## SCAPPOOSE PLANNING COMMISSION

##### 5.1 Docket # CU 1-26, PLA 1-26

Scappoose Hospitality Group, LLC has requested approval of a consolidated application for Conditional Use (CU 1-26) to allow for the construction of a hotel and various site amenities as well as Property Line Adjustment (PLA 1-26) between the subject site and Tax Lot 700. The site is located at an unaddressed property off NE Wagner Court, southeast of the NE Wagner Court and West Lane Road intersection, on property described as Columbia County Assessor Map #3106-CO-00800.

**CITY OF SCAPPOOSE  
PLANNING COMMISSION STAFF REPORT**

# Exhibit 4H

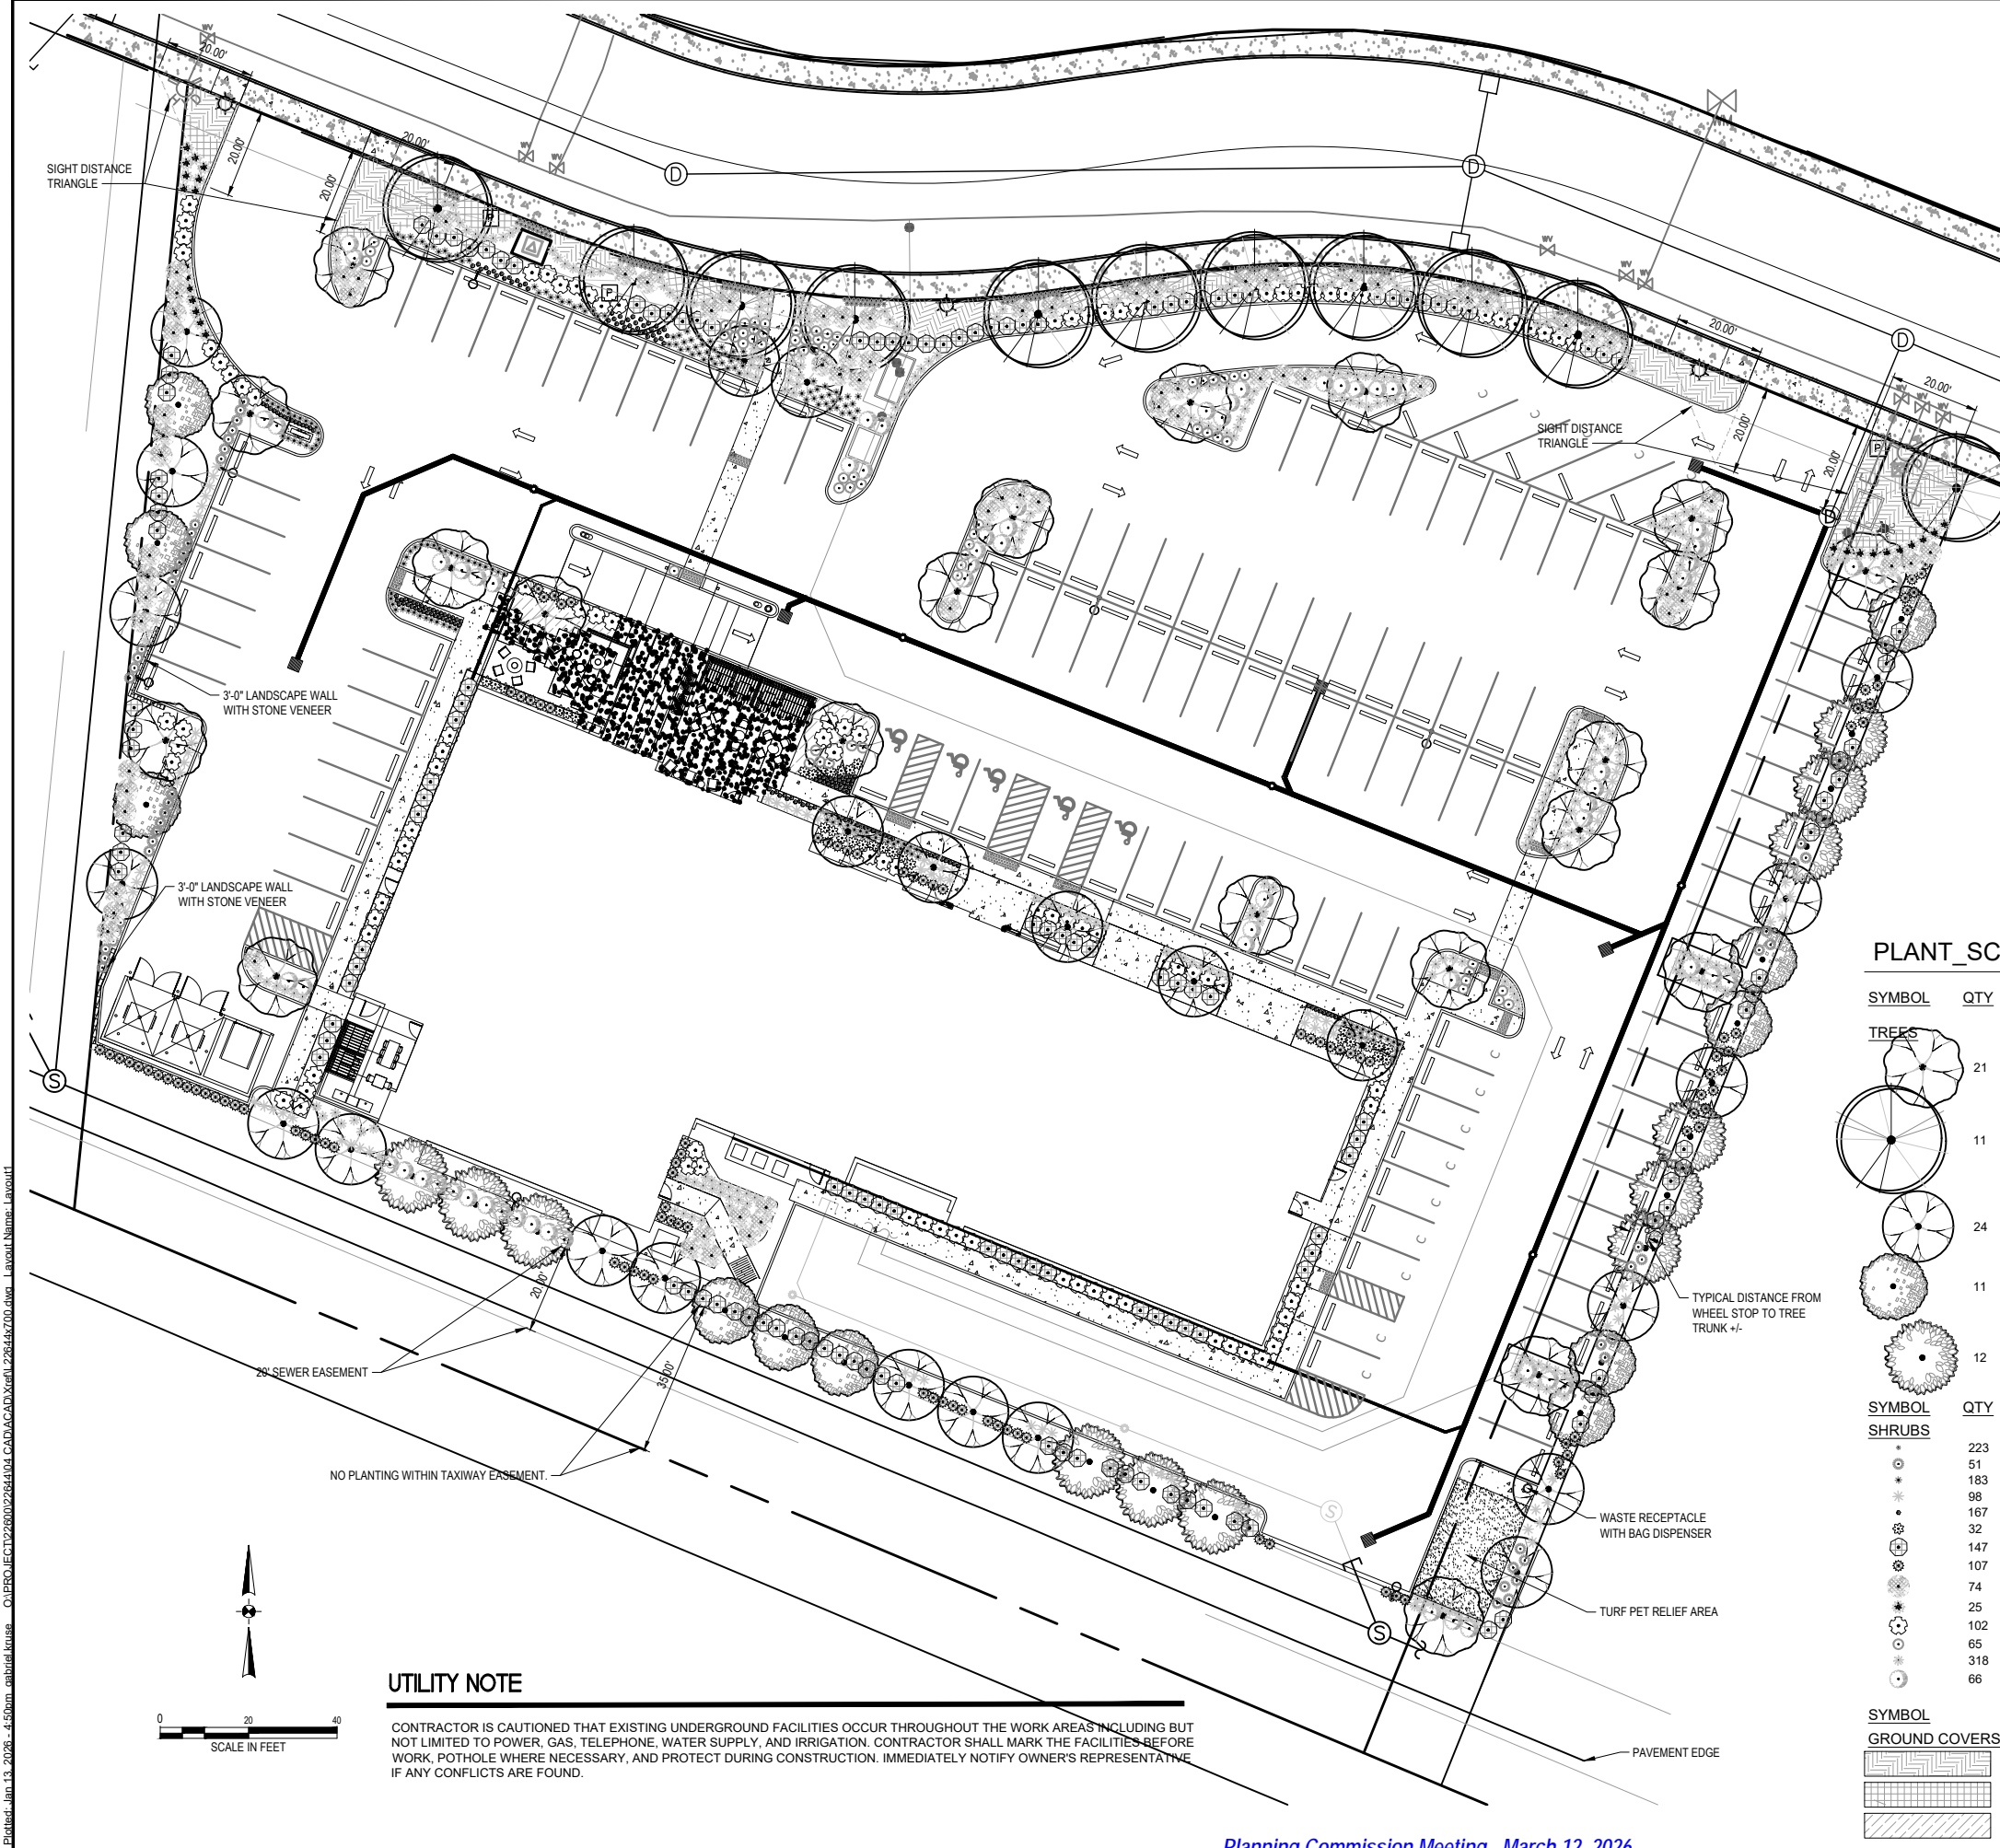
### **Landscaping and Sheet L1 – tree height limits**

Sheet L1 shows proposed trees and landscaping, including trees intended as visual screening for the new building. To maintain long-term access for ground and aerial ladder operations to the second and upper floors, the following requirements apply along the building perimeter and aerial apparatus access road:

Tree species currently specified on Sheet L1 with listed or typical mature heights exceeding 7 feet (including Acer griseum 'Fireburst' / Fireburst Paperbark Maple, Acer x 'Pacific Sunset' / Pacific Sunset Maple, Ginkgo biloba 'Princeton Sentry', Magnolia grandiflora 'Edith Bogue', and Morella californica / California Wax Myrtle) shall be relocated outside of these restricted zones or replaced within those zones with alternative species that do not exceed 7 feet at maturity.

Sheet L1 shall be revised to ensure landscaping does not interfere with required aerial fire apparatus operations for the proposed four-story hotel. All trees and vertically growing plant material located along the designated aerial fire apparatus access side of the building, and within 10 feet of the edge of the aerial fire apparatus access road on that side, shall be selected and maintained so that their mature height does not exceed 7 feet.
